Addendum No. 01

Date	October 1, 2026	Pages	4 (incl. 2 drawings)
To	All Bidders	From	Neil Caldwell, P.Eng PMP
Client No.		Jp2g No.	24-5090F
Project	St. Regis Police Station Site Upgrades	Contract:

MOHAWK COUNCIL OF AKWESASNE
ST. REGIS POLICE STATION SITE UPGRADES

ELECTRICAL
DETAILS, LEGENDS AND
DRAWING LIST

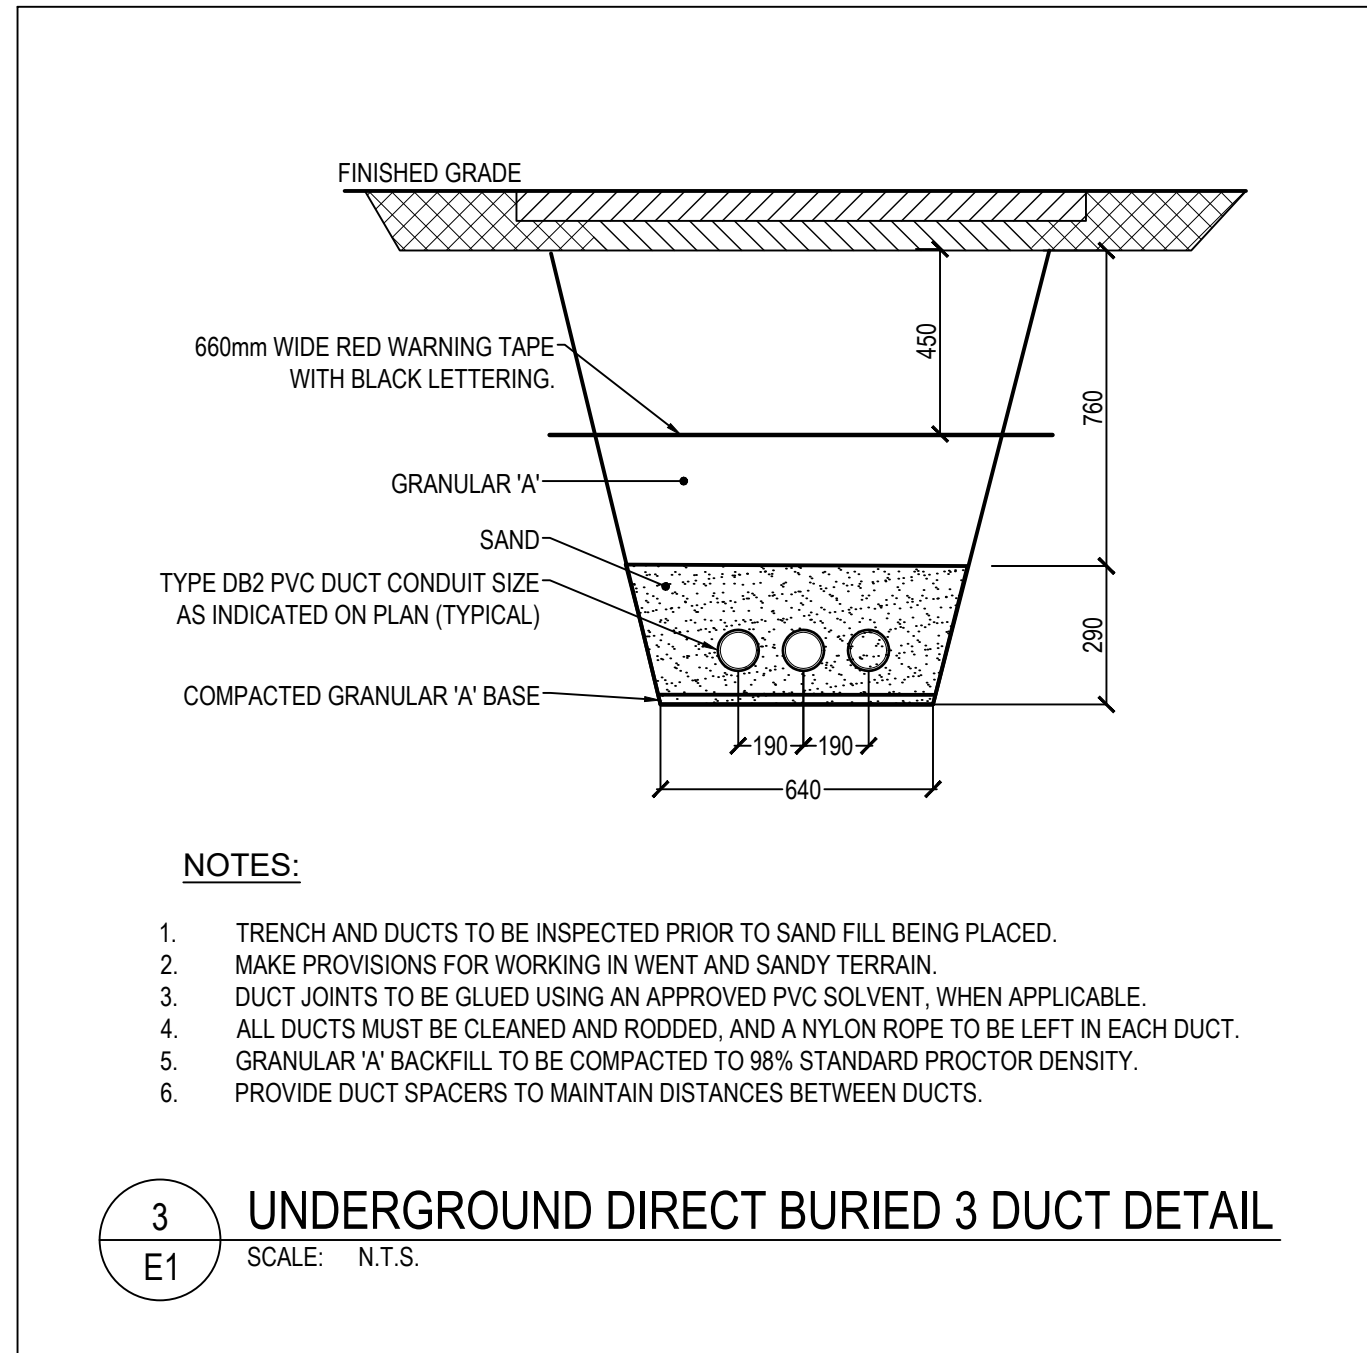
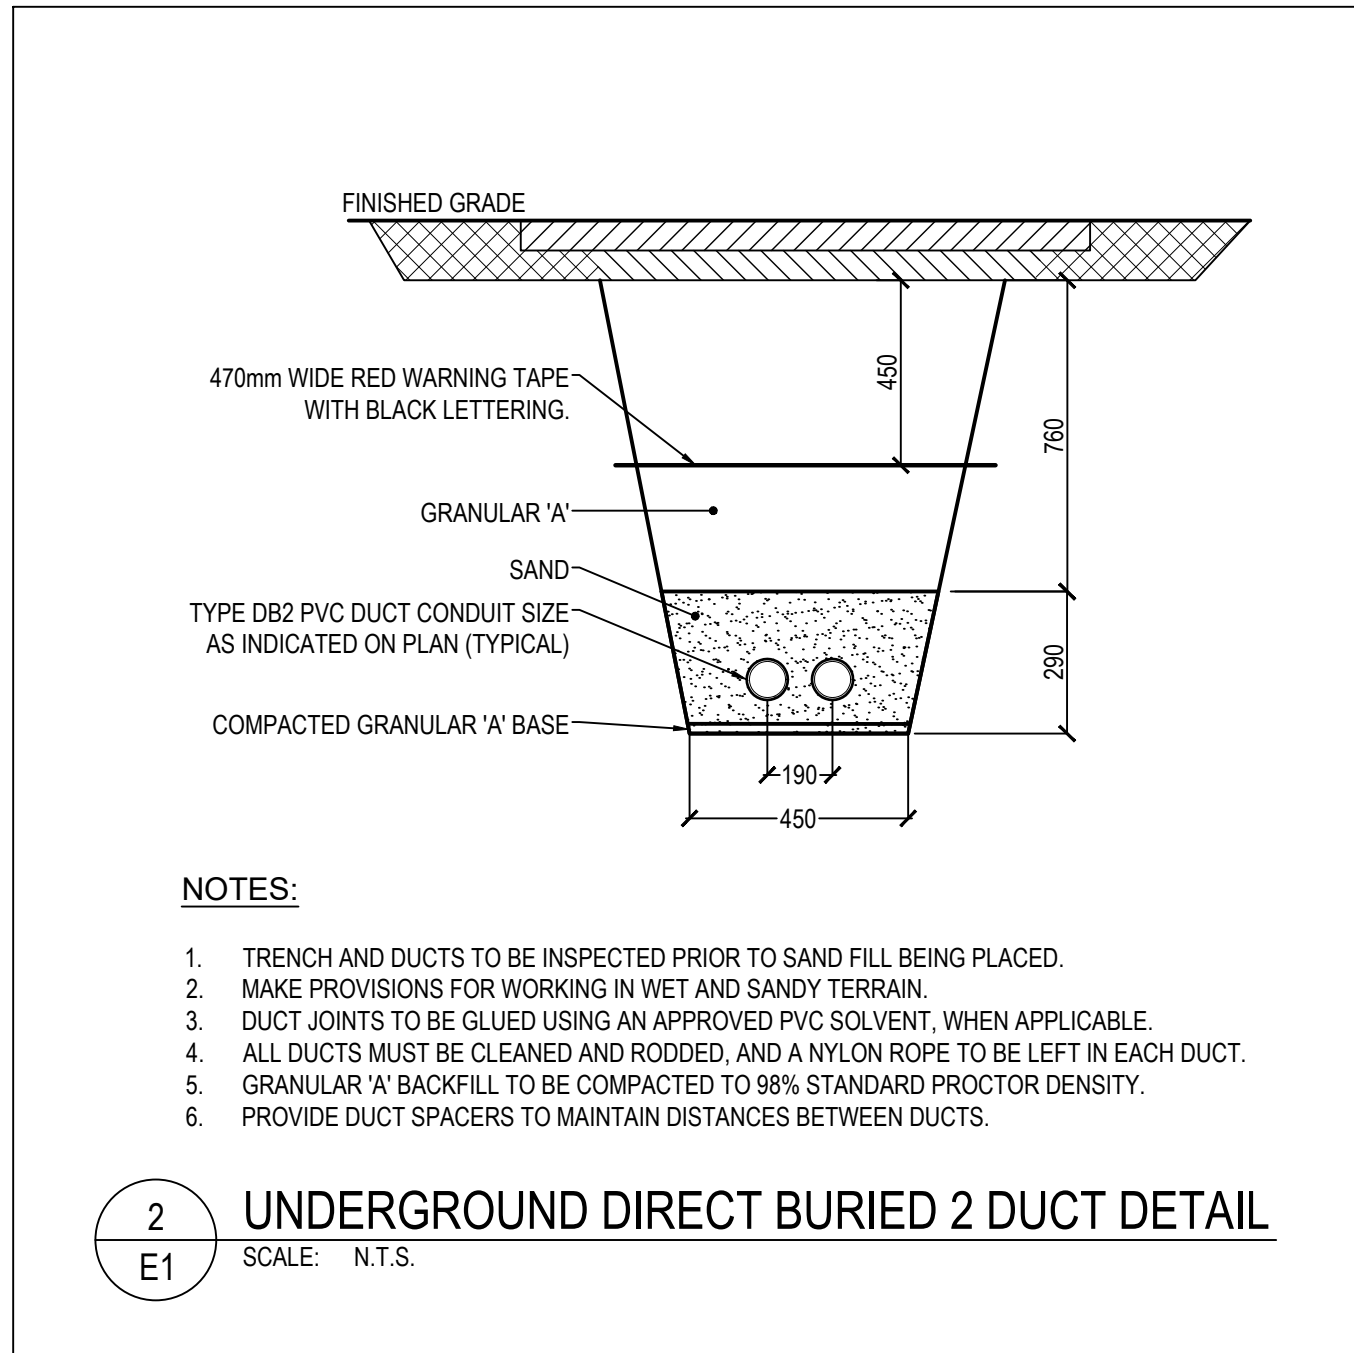
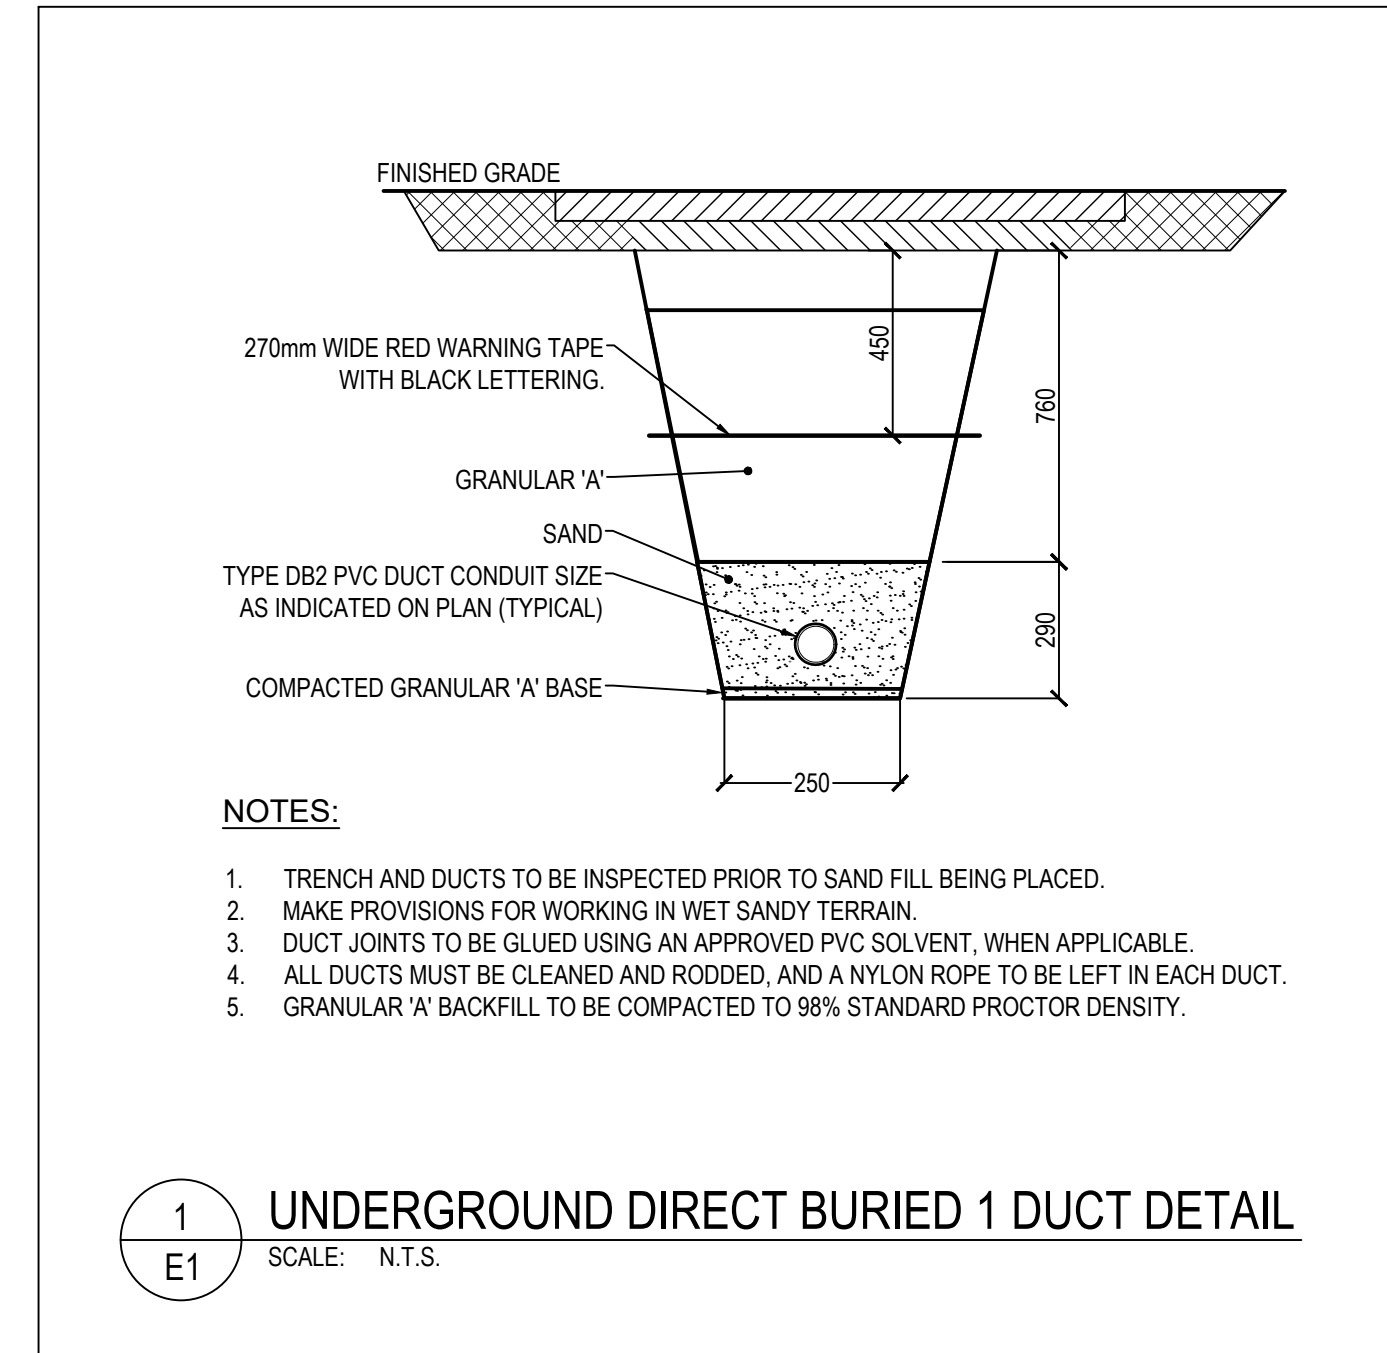
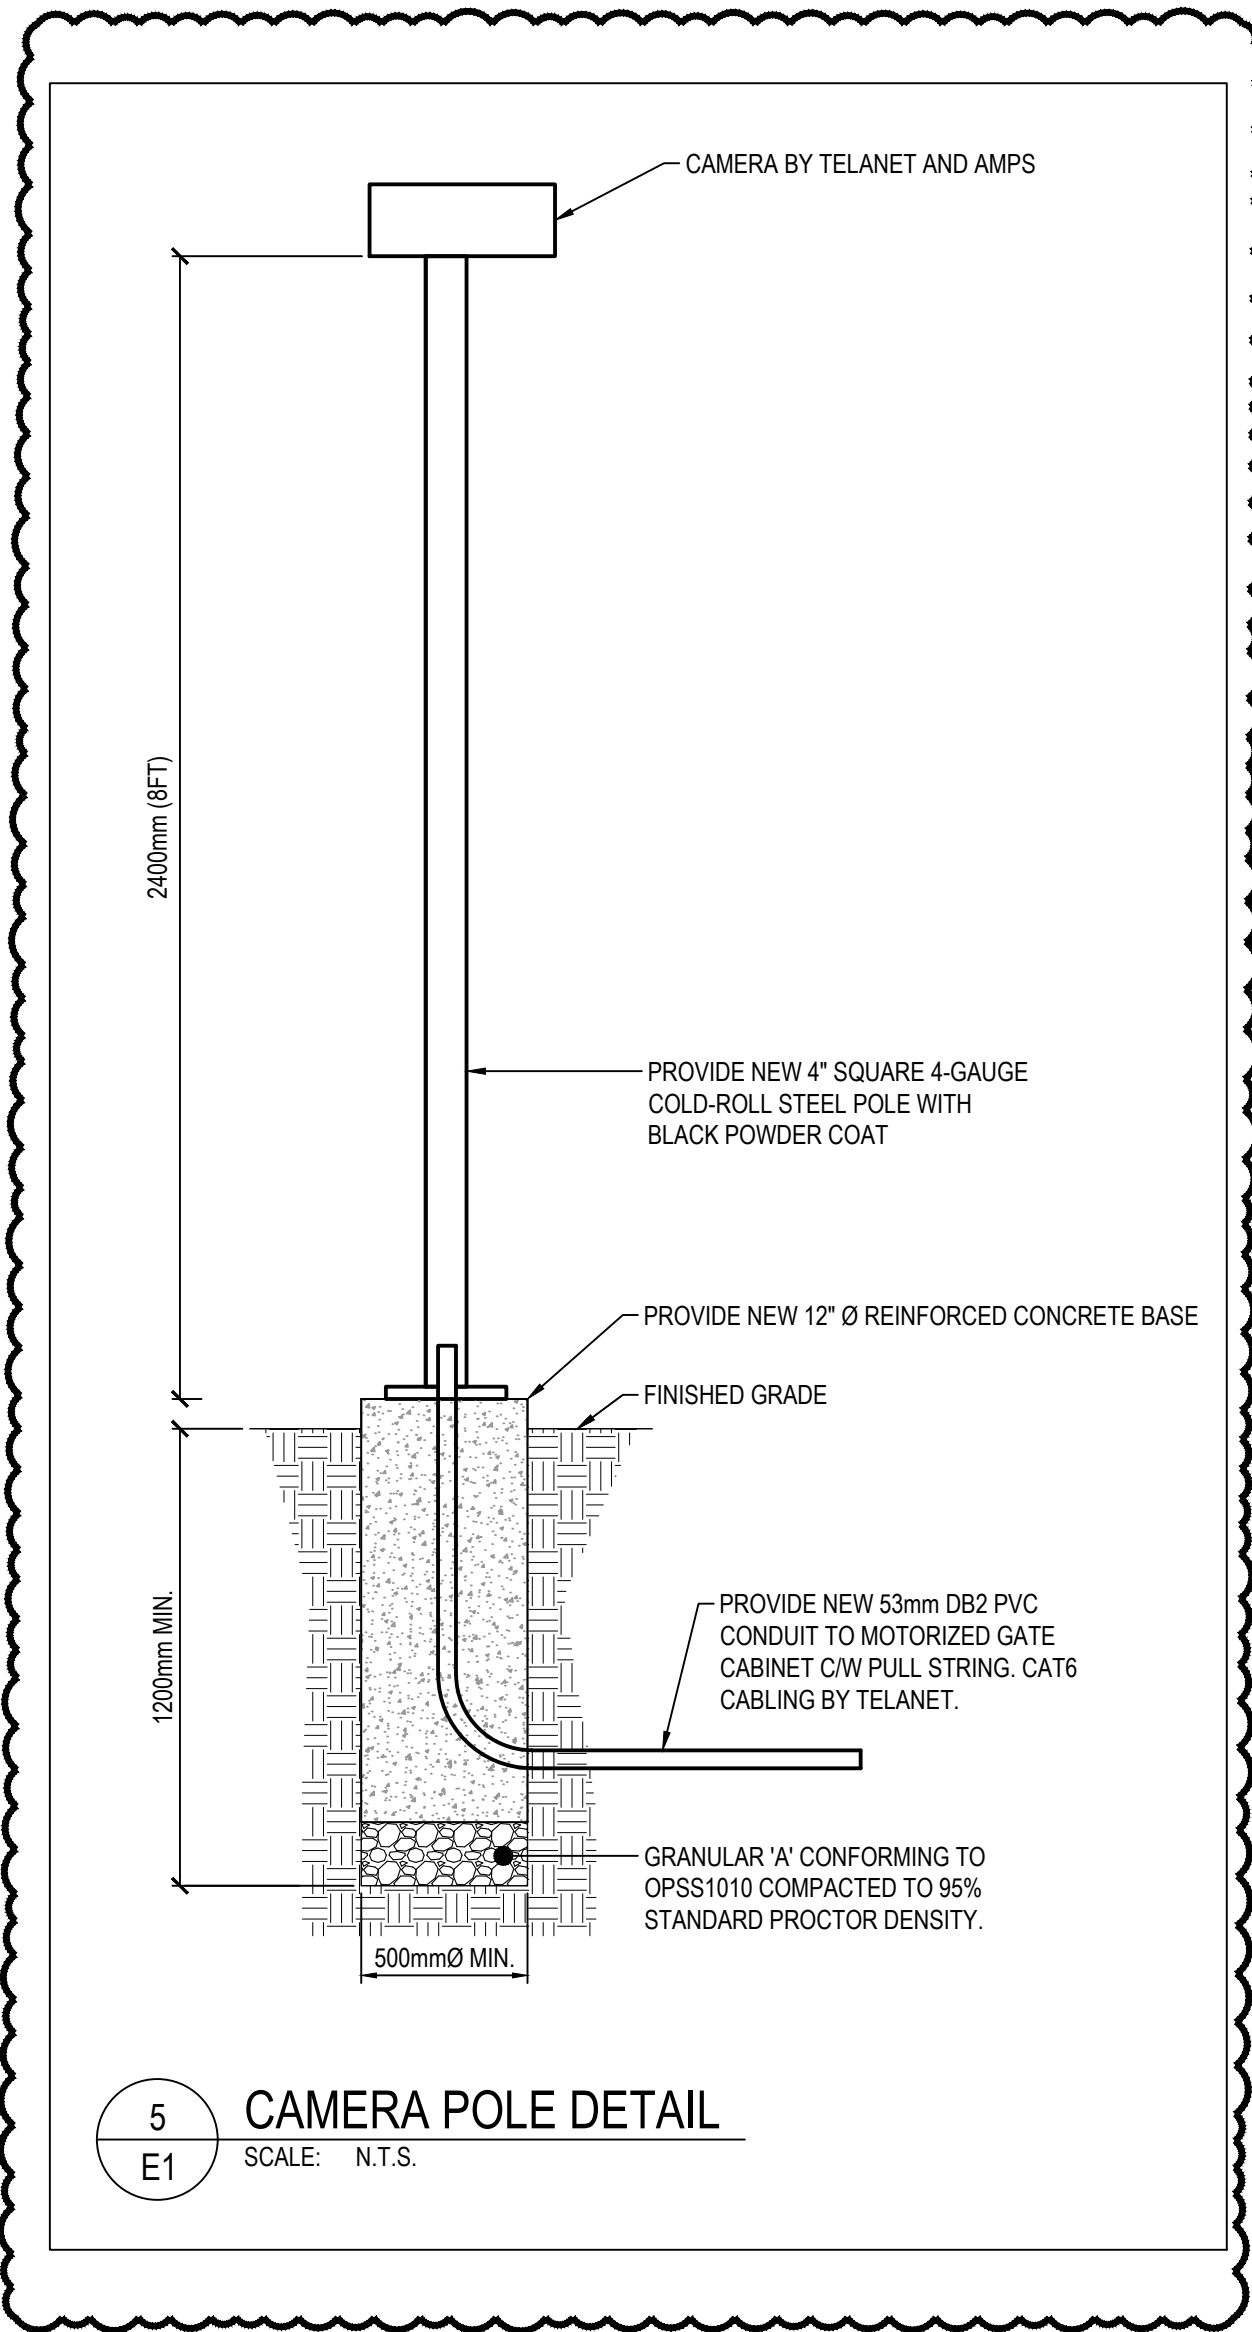
- i. Electrical **Drawings E1 and E2 are reissued for addendum #1 included with this addendum**, summary of changes include:

1. Reconfiguration and quantity of ducts.
2. Addition of camera pole and associated ducting.
3. Update location of electrical and communication tie ins in building.
4. Update to panel connections.
